3. Midtown Project

3.I. PB Report

3.IV. Response To Staff Comments 11-24-15

3.V. Response To Staff Comments 1-13-15

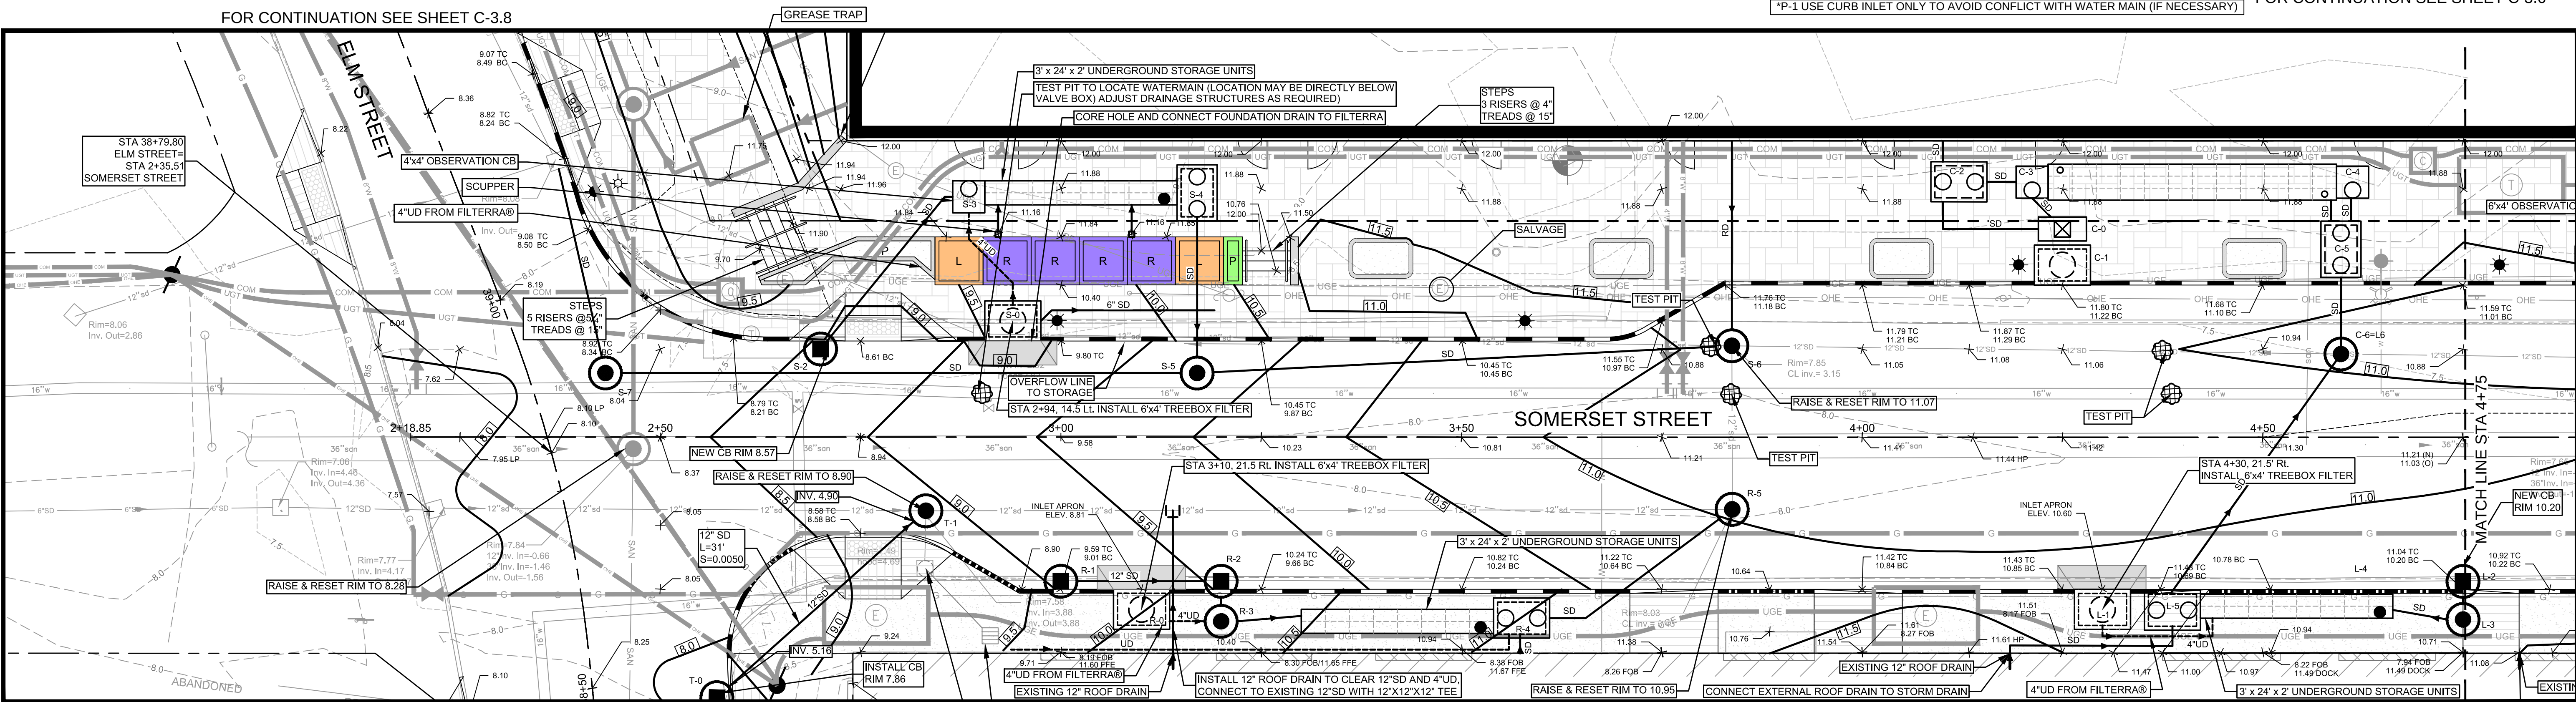
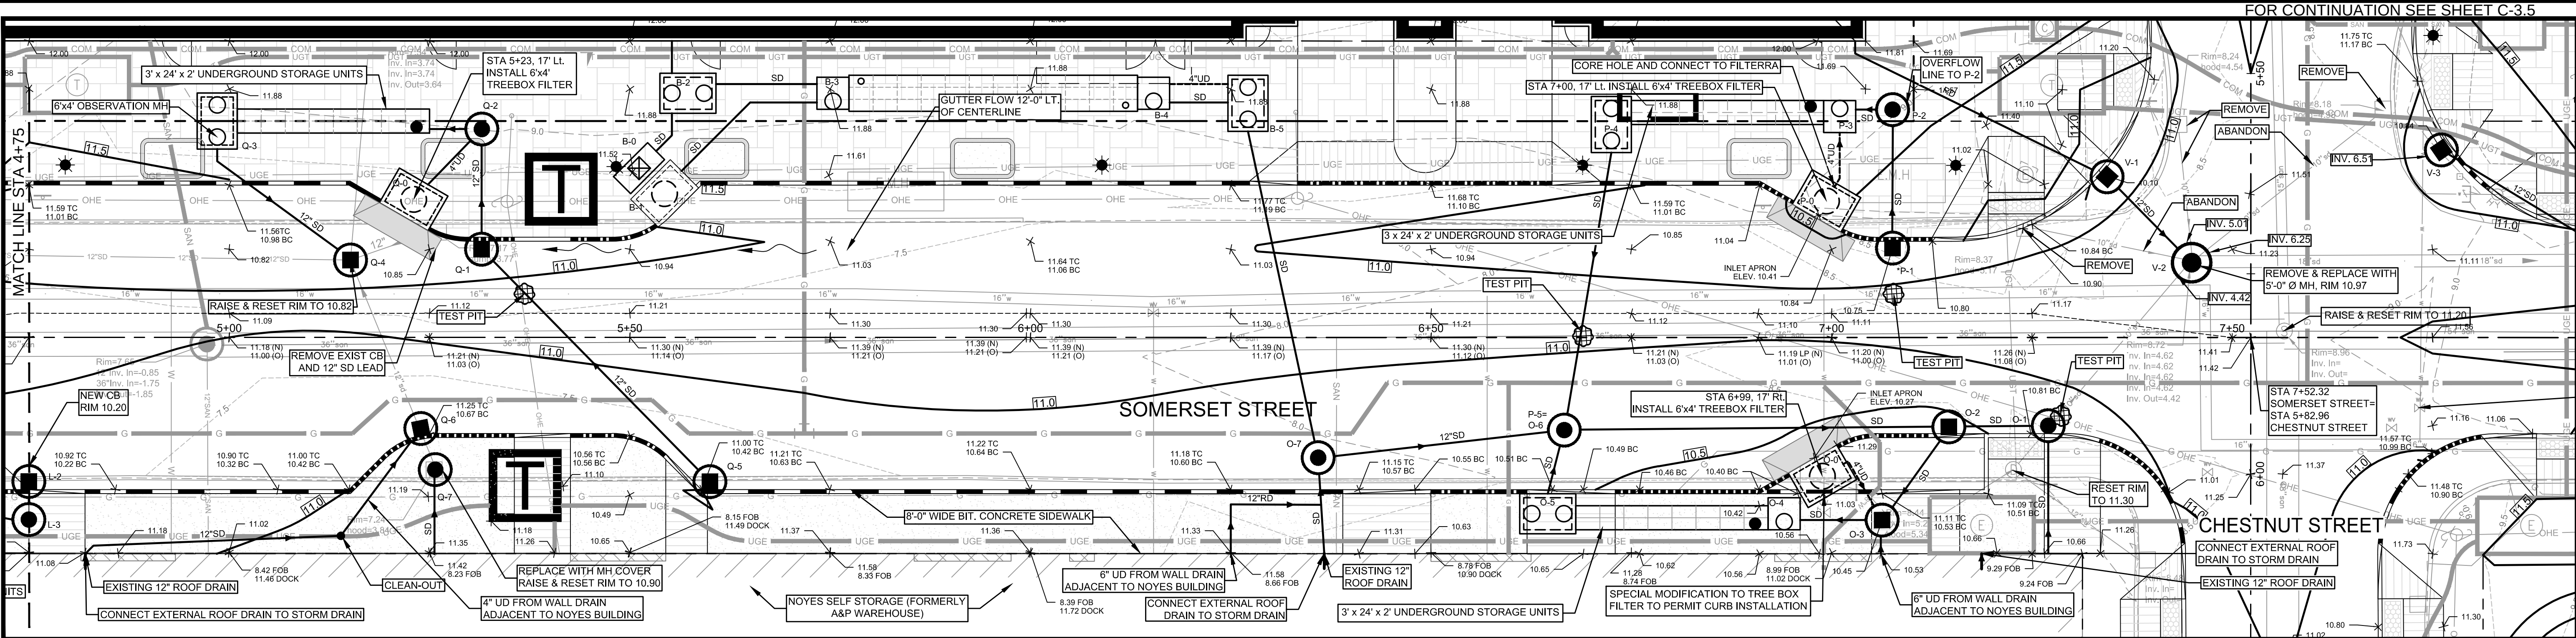
- b. The plans show a 12" catchbasin lead from E-9 on drawing C-3.3 connecting to a 24" sewer without a manhole at the intersection of Pearl and Somerset Streets. This is not allowed by City Code which states: All connecting pipes eight inches and larger require manholes. Please provide a manhole at this junction point.

- d. A catchbasin is proposed in the sidewalk, approximate station 2+90, drawing C-3.3, at the Noyes building near the corner of Elm Street. Catchbasin in sidewalks are not allowed.

SOMERSET STREET PROFILE FACING NOYES

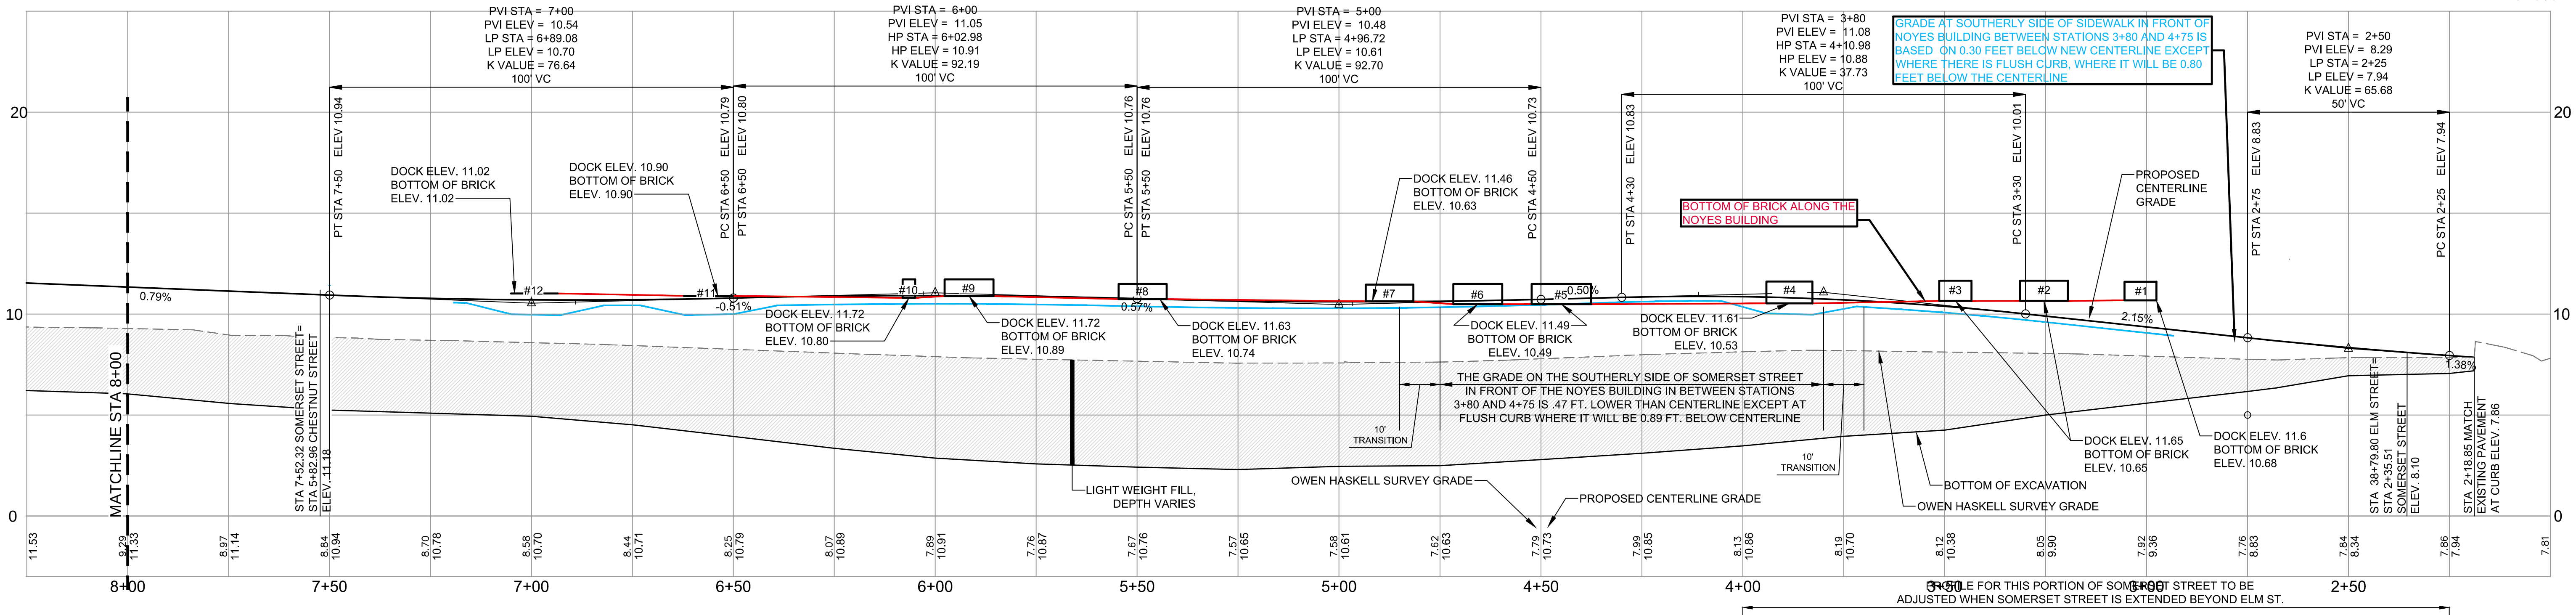
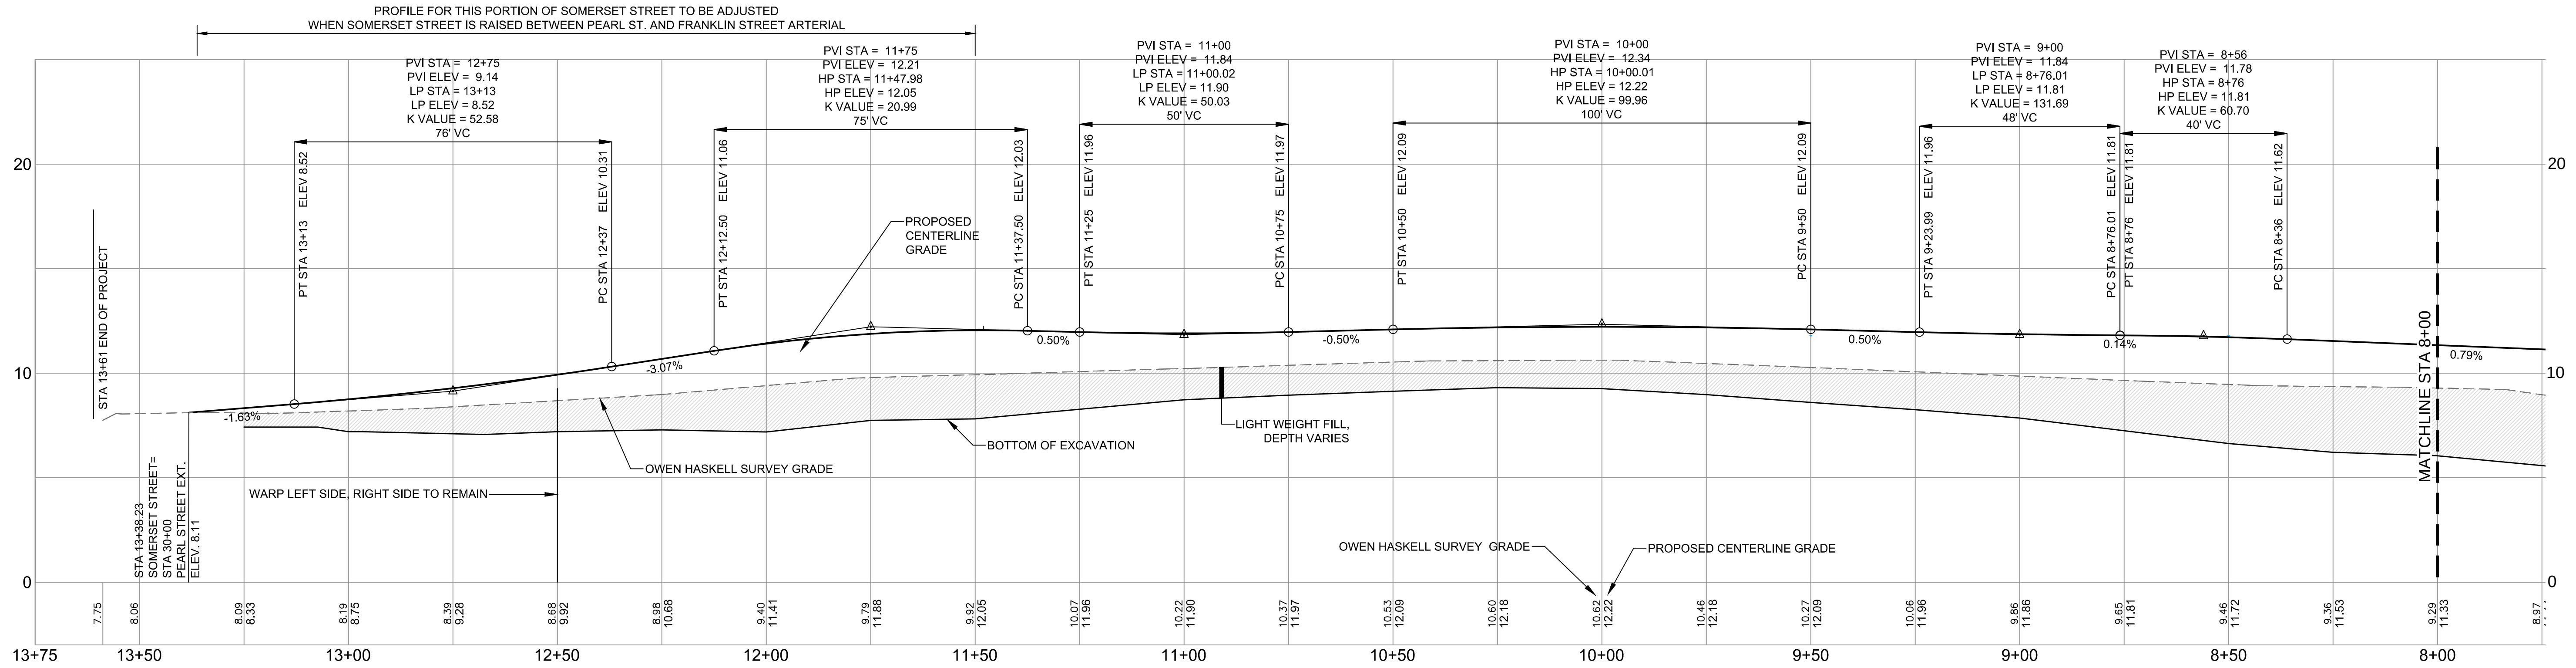
- e. All the proposed underdrain along the face of the Noyes building does not appear to be shown. Drawing C3.4 approximate station 5+25. Please verify.
